City of Westlake

Planning and Zoning Department – Staff Report

PETITION NUMBER: MSP-2026-02 Master Sign Plan for Cresswind Palm Beach
OWNER: KH Westlake, LLC
APPLICANT: Urban Design Studio, Inc.
ADDRESS: N/A
PCN: 77-40-43-12-13-019-0000 & 77-40-43-01-14-016-0000

REAR ENTRY
MONUMENT
SIGN

Subject Residential Pod Entry Monument Sign (Already Built)

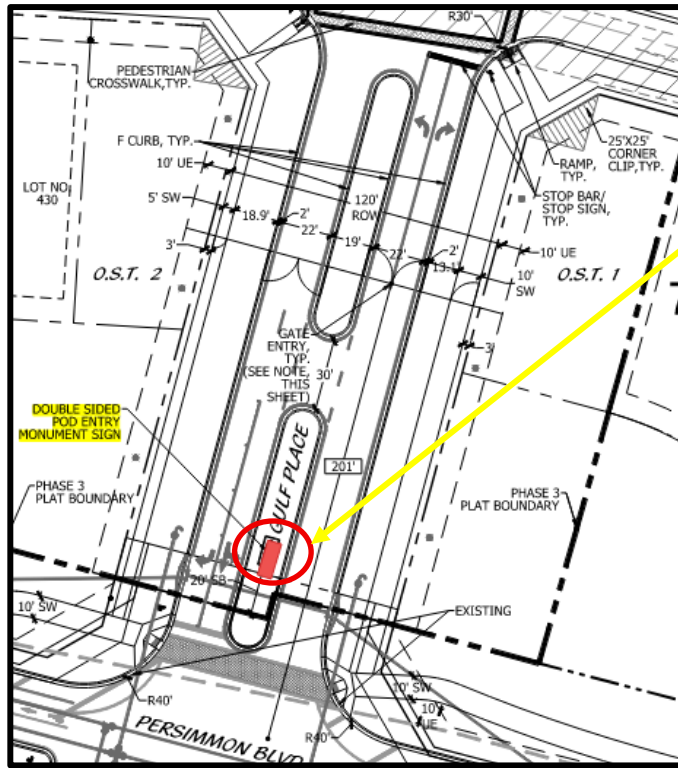
The second sign is an entrance monument sign that was permitted with conditions. However, it was not built in compliance with the approved plans or the required design consistency standards. The applicant is requesting a retroactive Master Sign Plan approval to address the dimensional and design deviations associated with this built sign. The monument sign includes approximately 44 square feet of copy area, which is below the maximum 60 square feet permitted under Chapter 113 of the City of Westlake Code of Ordinances.

The application includes three (3) waivers from the City's sign code related to monument base height, sign width, and sign area. Please note the already built sign has currently a stop work order (see attached).

1. The subject sign shall be revised to include materials and colors similar to the sign located at the main entry (Town Center Pkwy).
2. Except as modified by the approved waivers, the monument sign shall comply with all applicable provisions of Chapter 113 of the City of Westlake Code of Ordinances.
3. Any sign illumination shall comply with Section 113-15 of the City sign code.
4. The sign and landscaping shall be maintained in good condition.

Proposed Residential Pod Entry Monument Sign

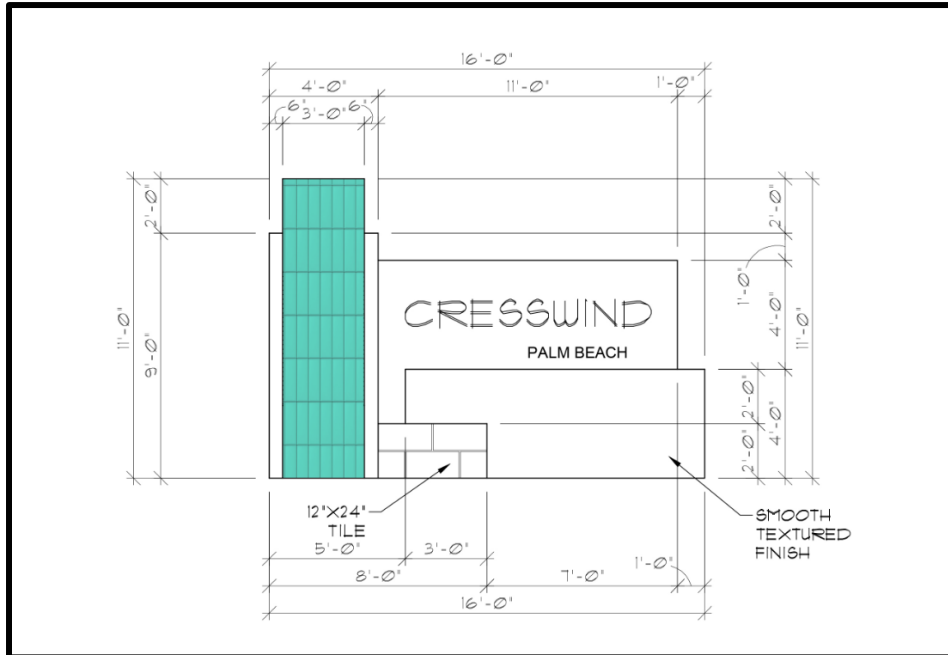
Waiver 1 – Monument Base Height: To allow a monument base height of eight (8) feet.

Waiver 2 – Totem Element Width: To allow a deviation from the standard Residential Pod Entry Monument design shown in Figure 113-11-3.

Waiver 3 – Alternative Monument Design: To allow deviation for the design of Residential Pod Entry Monument Sign per Figure 113-11-3.

The applicant has already constructed a monument sign located on Persimmon Boulevard East. The sign consists of white stucco, black 12" x 24" tile, and a totem feature finished with blue tile.

Staff Finding: Staff finds that the additional height is integrated into the architectural composition of the entry monument and is consistent with the scale and character of the previously approved Cresswind Palm Beach entry signage.

Staff Finding: Staff finds that this minor increase in width does not significantly alter the overall scale of the sign and remains visually compatible with the existing monument signage within the community.

Staff Finding: Staff finds that the integrated design maintains the architectural character of the Cresswind Palm Beach development and supports a cohesive and coordinated community entry feature.

NOT APPROVED

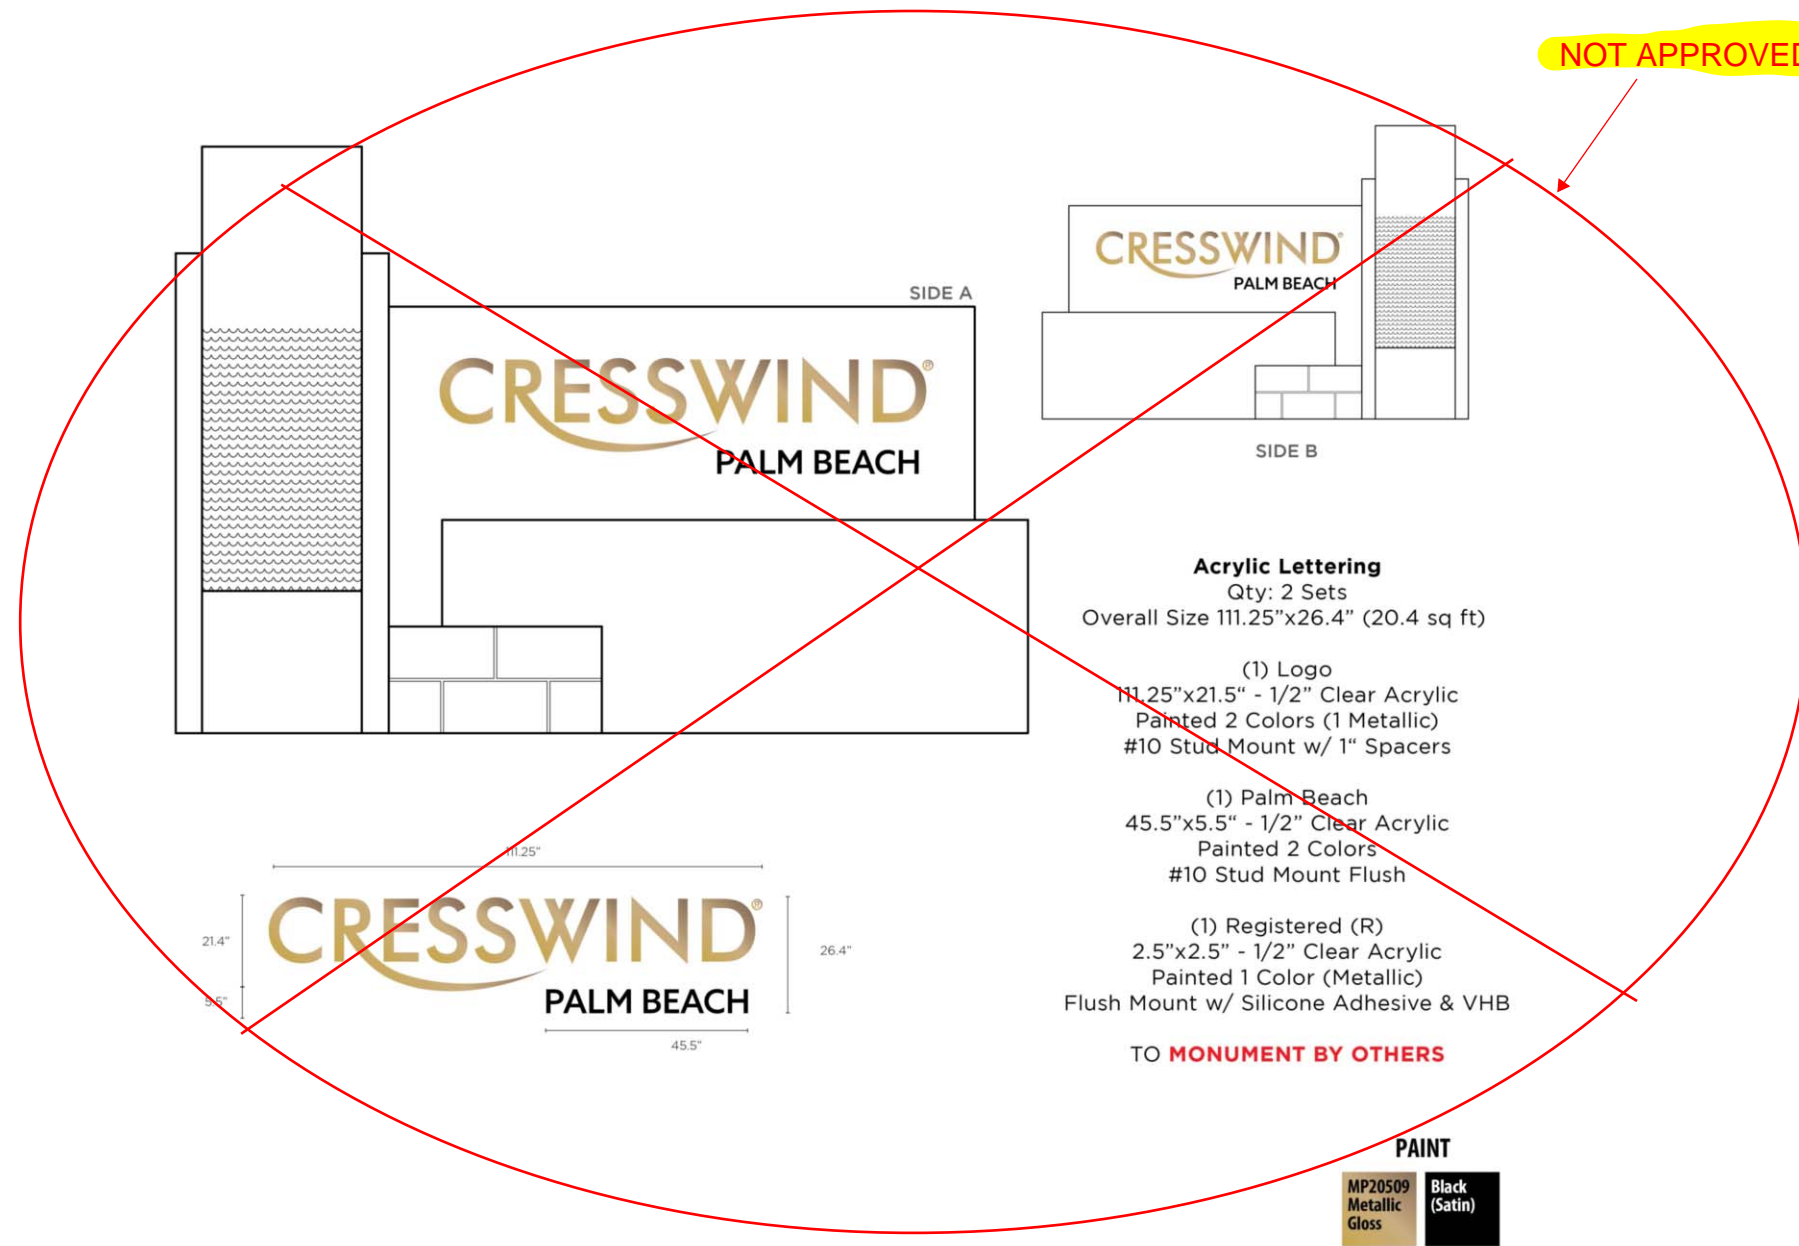
COLOR SHALL MATCH THE OTHER MONUMENT SIGN IN THE CITY

NOT APPROVED

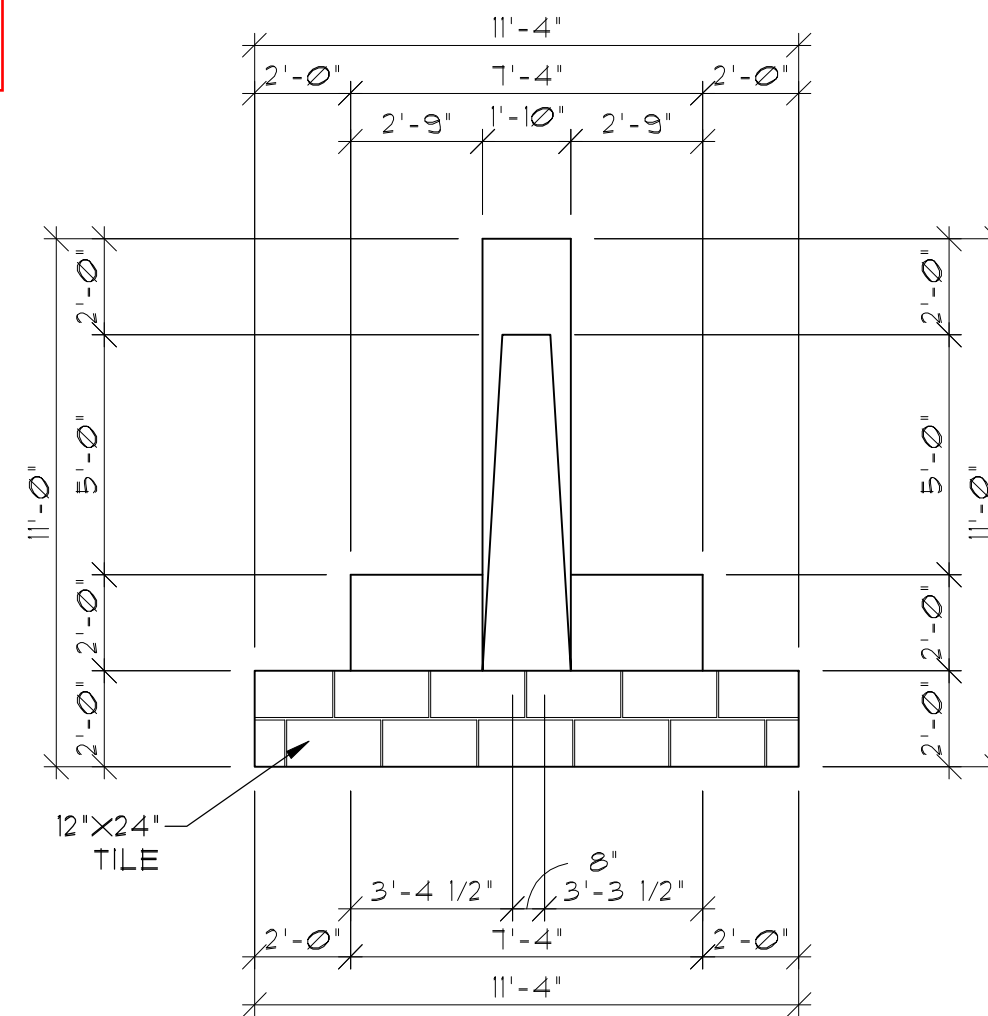
COLOR SHALL MATCH THE OTHER MONUMENT SIGN IN THE CITY
